SBM-23-2071

**Re: Response Letter for SPA2 Submission Comments  
Proposed Warehouse  
33 Park Road, Simcoe, ON**

This response letter has been prepared by Strik, Baldinelli, Moniz Ltd. (SBM) to address the requirements of the Site Plan Approval Comments, received and updated September 10, 2025, for the proposed development located at 33 Park Road in the County of Norfolk (County). This response letter shall be read in conjunction with the Site Plan and Engineering Documents prepared by SBM.

SPPL2024304

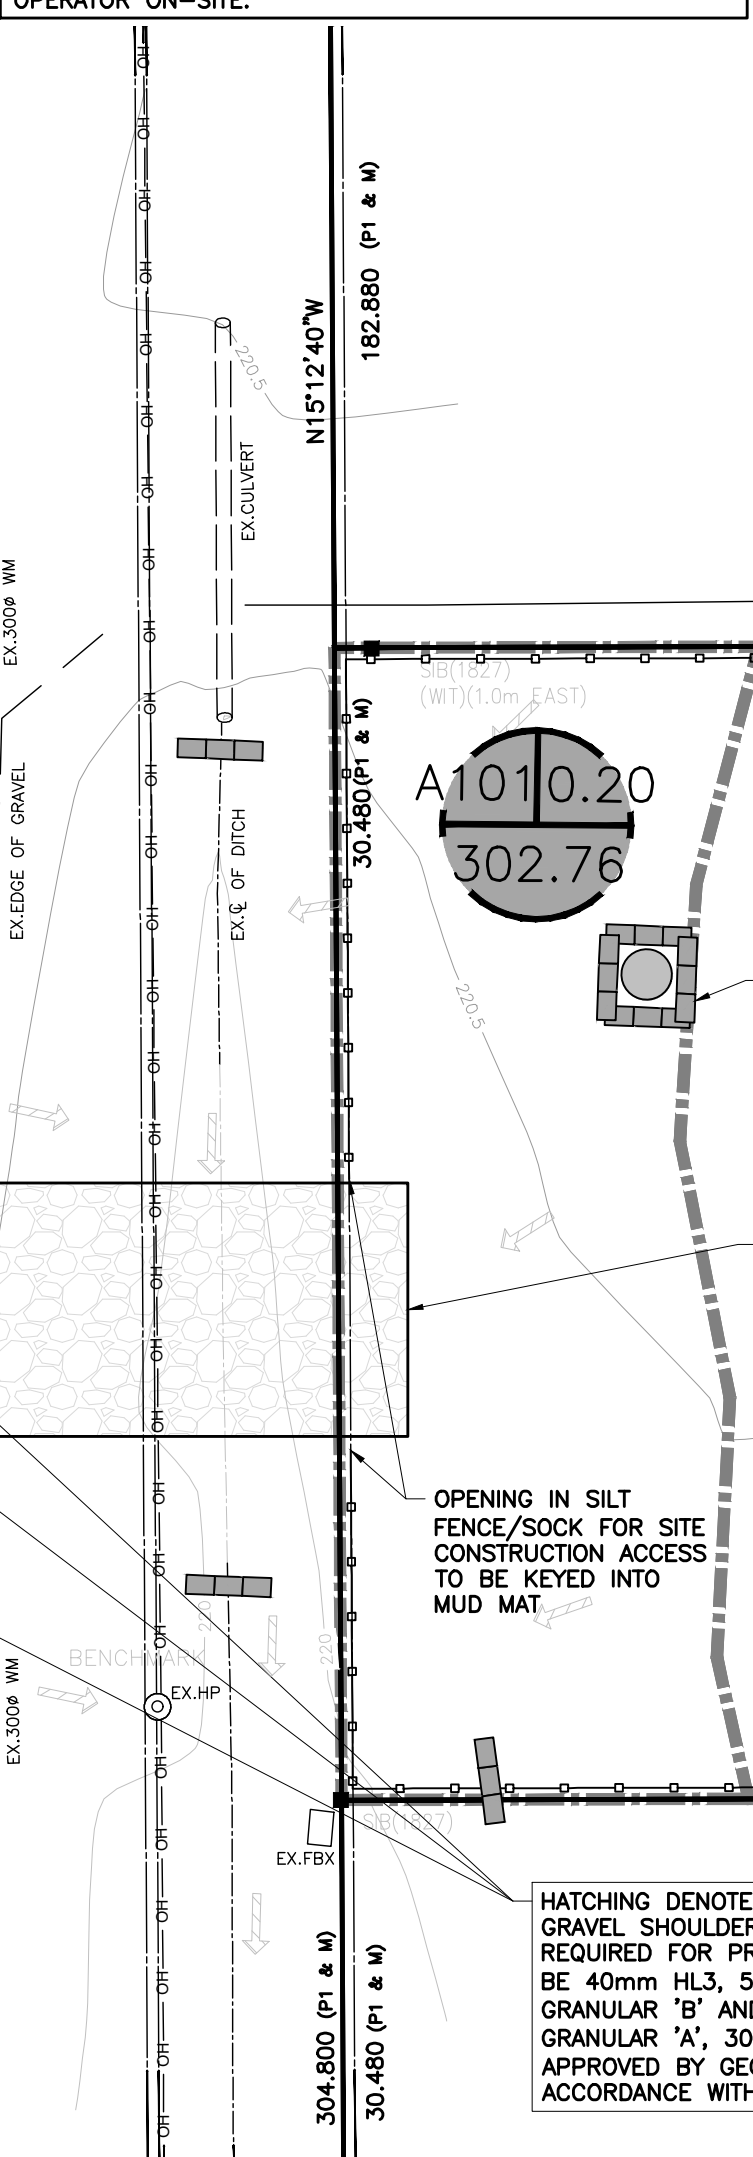
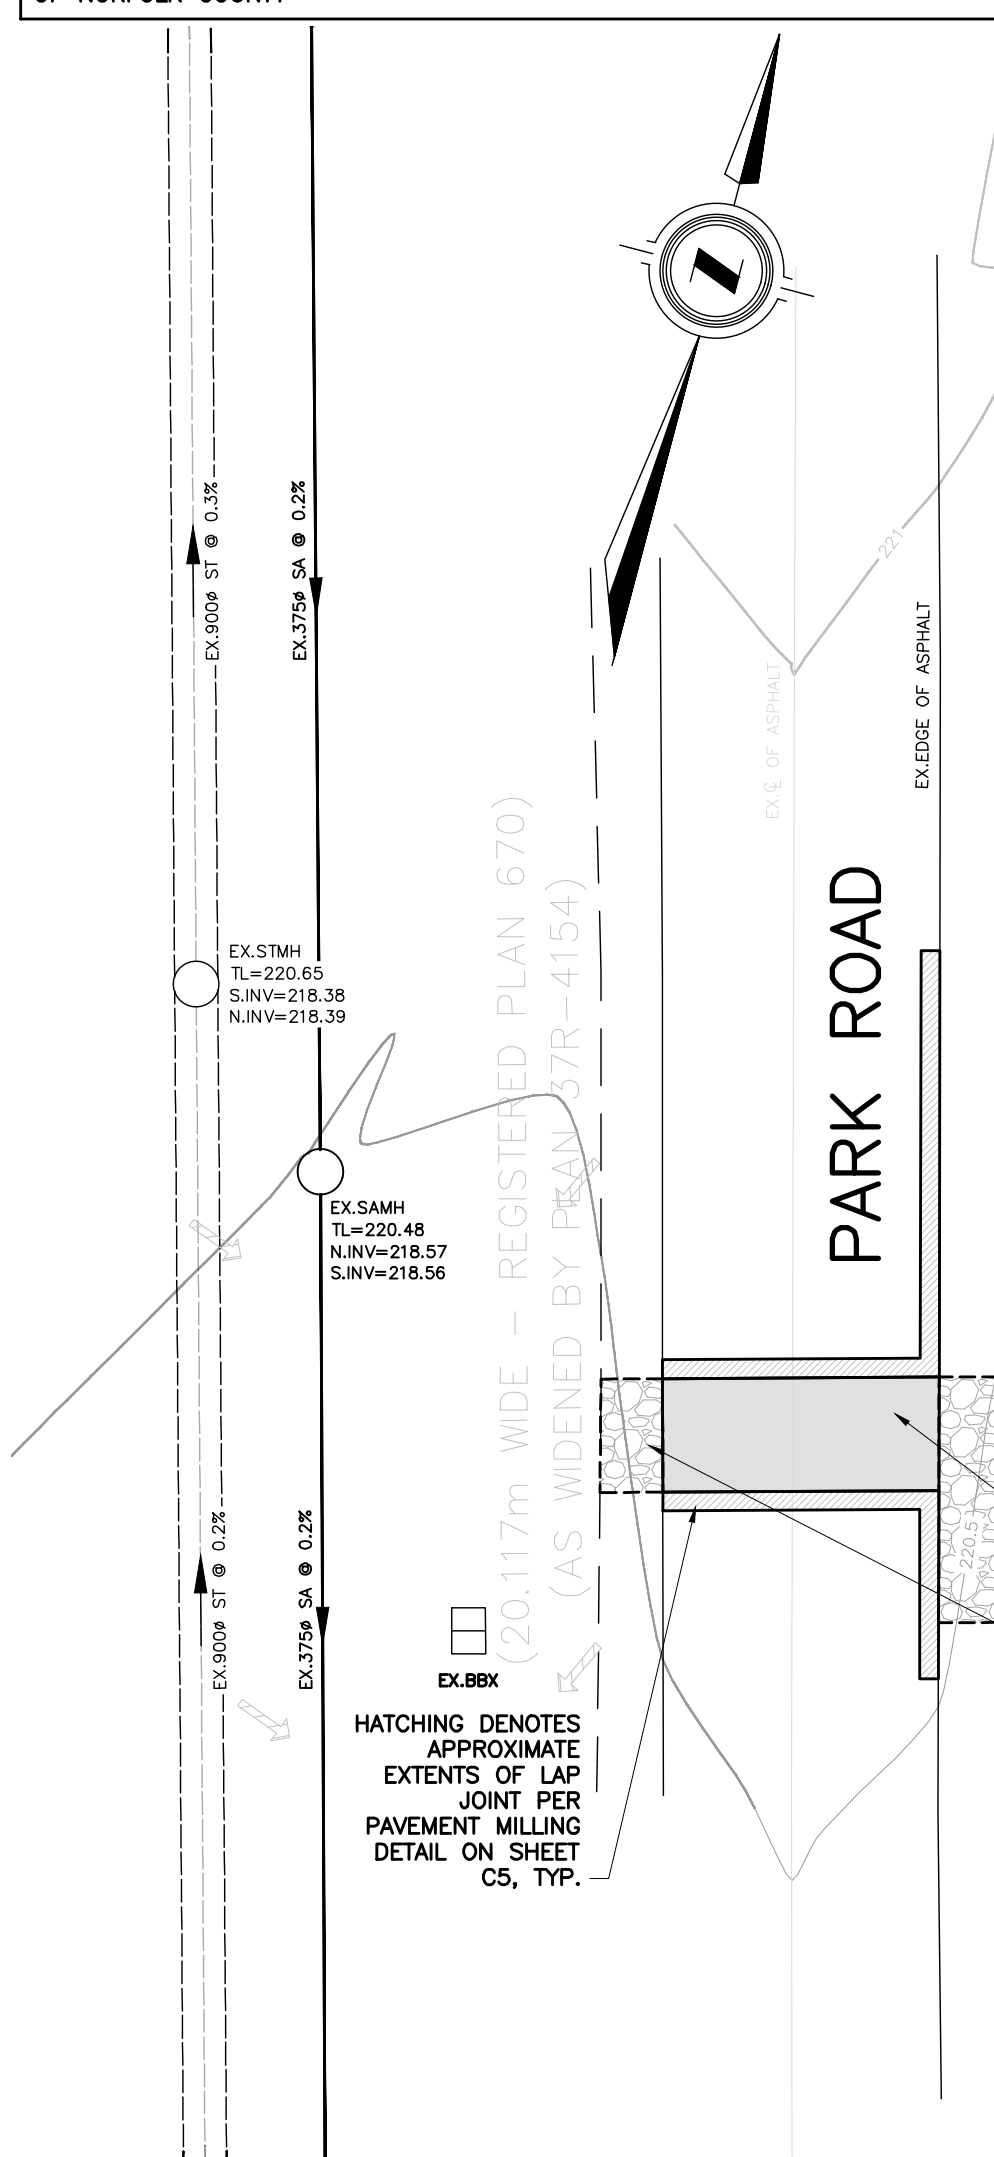
6. Following construction, an inspection of the outlet and riprap protection is recommended to confirm stability and effectiveness.

*Response by SBM: Acknowledged. Refer to notes on drawing and in the design brief which speak to post-construction ESC review. Specifically, ESC Note 20 on sheet C1 as well as an additional site review item in the "List of items requiring engineer's review" table on sheet C1.*
